Models 254,262

Flywheel

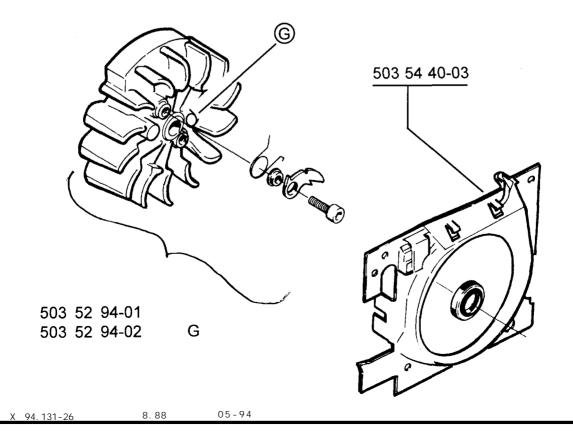
A new flywheel with larger capacity is introduced in order to improve the cooling of the engine. The fan blades are 2 mm higher, among other things.

In order to get room for the higher flywheel, another air conductor for this purpose has also been introduced. Both parts can be used on older saws.

NOTE! If a flywheel of later version is mounted a new air conductor must be mounted also.

New Ref. No. 503 52 94-01 503 52 94-02 503 54 40-03	Description Flywheel Flywheel G Air conductor	503 503	. Ref. No. 12 82-01 12 82-02 54 40-02	*
505 54 40-05 *	All conductor			
	from serial number:	3070072 3070366	254 262	
		0010000		
** Introduced	from serial number:	2220392	254	
		2210377	262
